IV. REMARKS

III. AMENDMENTS TO THE DRAWINGS:

Annotated Sheet

Fig.1

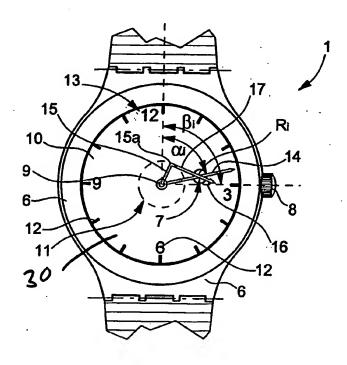
The drawings have been amended to designate the "optical valve," which is shown in original Fig. 1 and as originally described on page 6, lines 19-22, by the new character reference "30." The drawings, as originally filed, plainly show a "crown 8," which is a type of "external control member." Therefore, the drawings as originally filed illustrate an "external control member."

The attached sheet of drawings includes changes to Fig. 1. This sheet, which includes Figs. 1 and 2, replaces the original sheet including Figs. 1 and 2. In Fig. 1, the character reference "30" has been added to designate the "optical valve" described on page 6, lines 19-22, of the specification as originally filed.
